CITY OF PORTLAND, MAINE

FIRE PREVENTION BUREAU

SUBJECT: 82 Nanoues L9

SUBJECT: 82 Hanover Ct;

LOCATION OF GASOLENE TANK AT &4- HANOYER ST. GARAGE

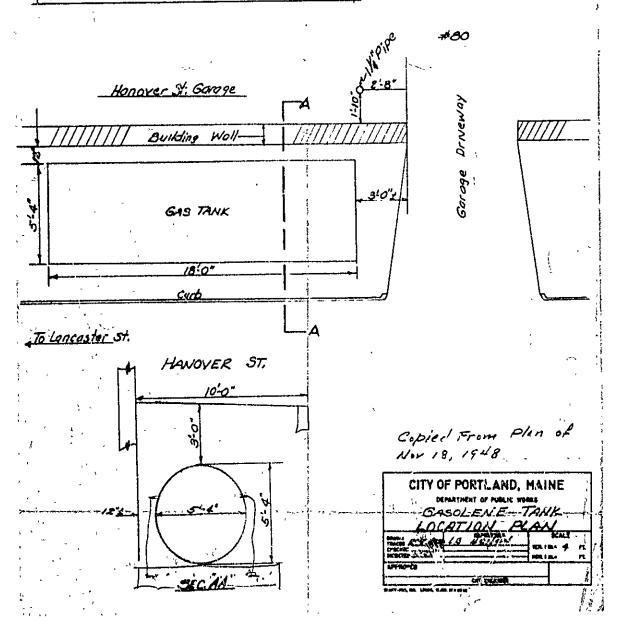
Before tanks and piping are covered from view, installer is required to notify the Fire Dept.Headquarters of readiness for inspection and to refrain from covering up until approved by the Fire Pept.Headquarters

These tanks of 3000 gallons capacity are required to be of steel or wrought iron no less in thickness than #? gauge; and before installation are required to be protected against corrosion, even though galvanized, by two coats of tar, asphaltum, or other suitable rust-resisting paint, and special protection wherein corrosive soil such as cinders or the like.

Pipe lines connected to underground tanks, other than tubing and except fill lines and test wells, must be provided with double swing joints arranged to permit the tank to settle without impairing the efficiency of the pipe connections.

Owner and installer will have to bear the responsibility for the structural capacity of the tank to support loads from above such as heavy motor trucks.

If tank will be so located as to be subjected to the action of tide water or "ground" water, adequate anchorage or weighting must be provided to prevent "floating" when tank is empty or nearly so.

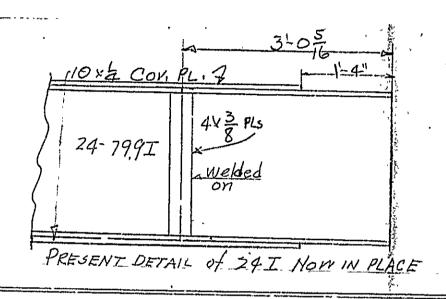
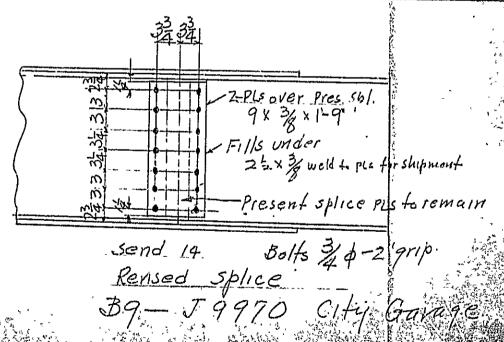
We enclose herewith sketch of splice we propose to use on the welded beam at the City of Portland Garage job, to reinforce present welded splice.

Will you please advise if this meets with your approvel.

To keep the work going we thought it might be well to handle the matter this way until such time askwek get our welders city approved.

1/15/46 - Talked with Mrs Wadsworth who said that he known nothing about this spliced beam, but that he would call. Meganin I Jours and have them sudhum shitely that he can hick it over. Jold him that RECEIVED we had no objection, if boths figure out to JAN 12 1946 take care of situation without the peneting SEPT. OF BLO'G. HISP. If you welled splice to take any of boat, but our diff of PORTLAND that we felt approved should don't don't from the writtent.
